SERVICE BULLETIN

Interface Unit IU-1507A Part Number 4001976-0751

Conversion of interface unit IU-1507A from Part Number 4001976-0751 to Part Number 4001976-0753

Figure 1. Interface Unit

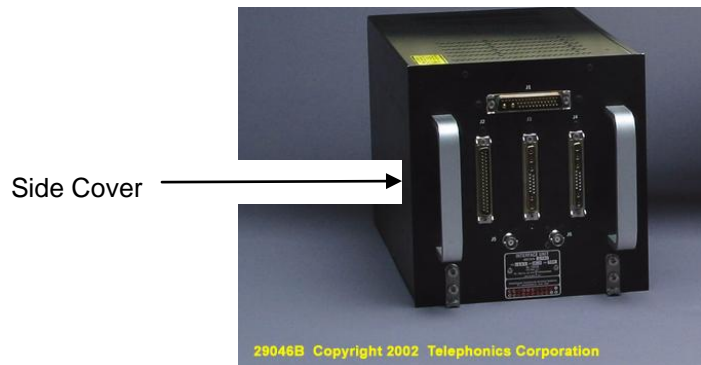
1. Place the unit (figure 1) on the work bench.

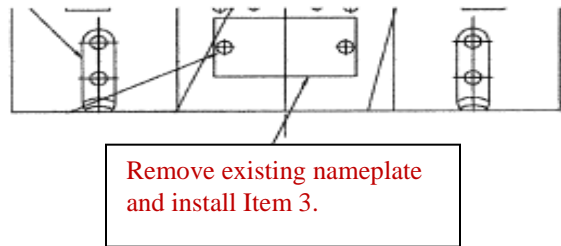
(a) Remove and replace microcircuits U5 and U12 per the following table:

Ref. Des.	Part Number	Replace With
U5	381-9E03-002	122-01855-0000
U12	381-9E03-001	122-01854-0000

5. Change marking on CPU Module CCA from “-0501” to “-0502”.
6. Replace CPU Module CCA 8057123-0502 in the reverse order of removal.
